marantz® SERVICE BULLETIN		Date: 8-Dec-2004	Model: LC3050/N1B
		Page: 1 / 1	REF.NBR: MZ04-079
Level		Application:	
★ ★		See below	
		Subject: Wipe effect.	
		Int.ref:

Service manual page 23

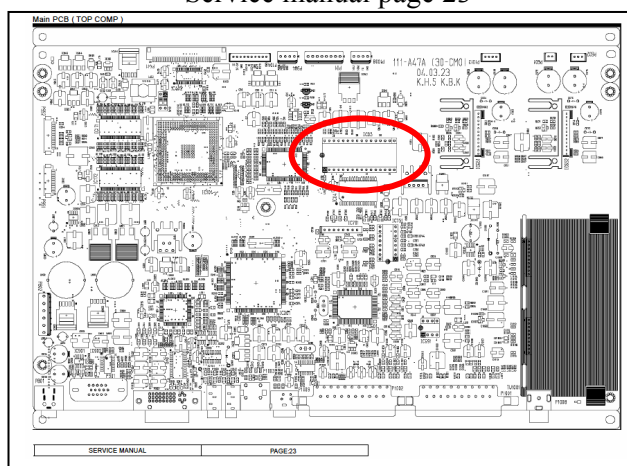
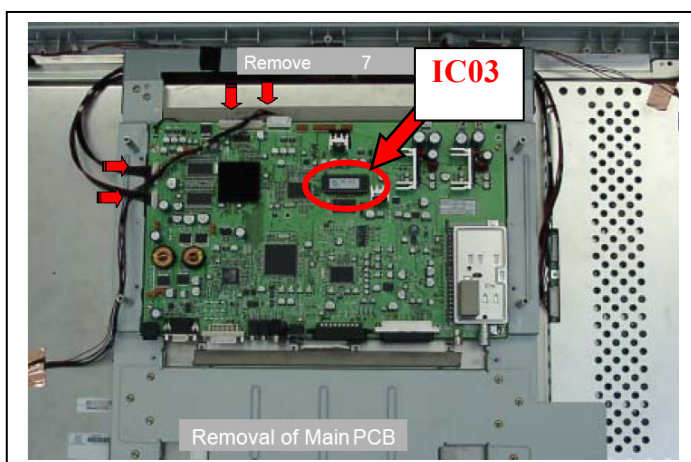
When you have on the screen a picture example of a face and the picture is moving slowly, it is like out of focus and you also get double contours.

1) Replace IC03 on the MAIN PCB.

POS.NO IC03 (EPROM programmed): **90M-HJ000010R**
